SUNDRY NOTICES AND REPORTS ON WELLS

Neff Federal #3

OXY USA Inc. - Proposed
Neff Federal #3
API No. 30-015-28281

RE: Plug back and Recomplete NOI – Conditions of Approval

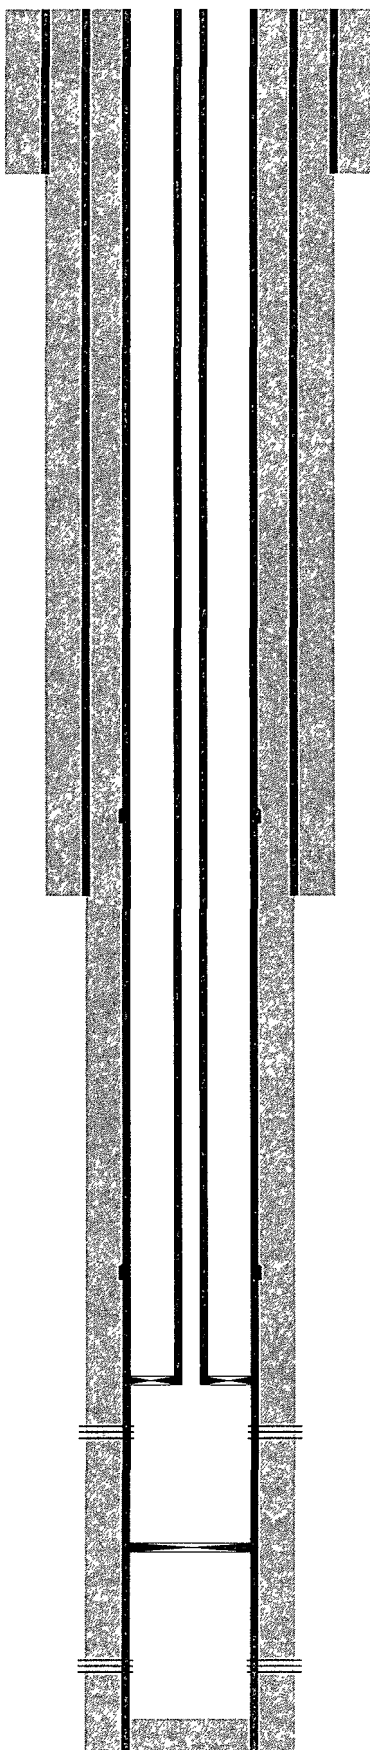
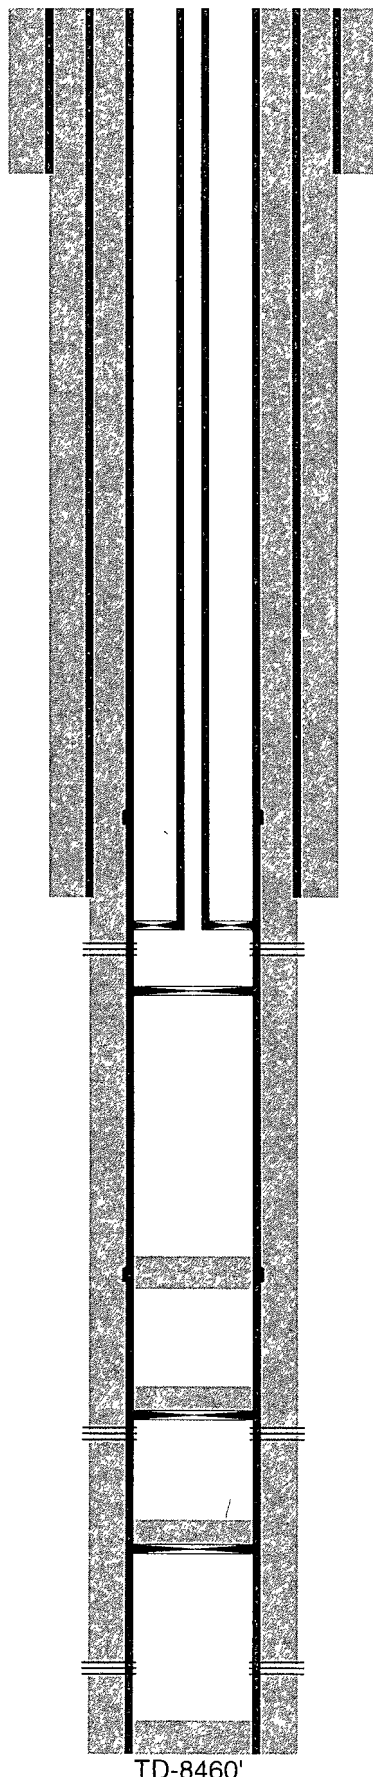
1. MI & RU DDP.
2. POOH w/Tbg and Packer
3. RIH & tag CIBP @ 7510', M&P 25sx cmt on top of CIBP
4. M&P 25sx cmt @ 6227-6127' WOC-Tag
5. Set CIBP at 4800'. POOH w/ tbg.
6. RU Electric Line Unit and perforate 4550-4600' & 4610-4660' W/
3-3/8" Power Jet 3406 - .37" holes w/6 JSPF (600 Total Shots) on 60 degree phasing.
7. RD ELU. Run Tbg and packer & set packer at 4500'.
8. Perform injection test on reservoir per the attached injection prog from Arc Pressure and report results to engineer. (Note: injection test will be run to determine if well will need stimulation to achieve the anticipated injection pressure and rate.)
9. Place well on injection.

1. OK
2. OK
3. Change: Drill out CIBP, and spot a minimum 25sx plug of Class H from PBTD to 8170'. If perfs drink too much cement, a CIBP can be placed after a 2nd attempt at 8170' with 35' bailed or 25sx pumped Class H. (Bone Spring – Perfs)
- 3a. Set CIBP at 7000' with 35' bailed or 25sx pumped cement as per schematic. (Perfs)
4. Plug to be a minimum 160'. Tag at 6067' or shallower – Otherwise OK (DV Tool)
5. OK
6. OK
7. OK
8. A NOI to stimulate the well will be required – Otherwise OK
9. OK
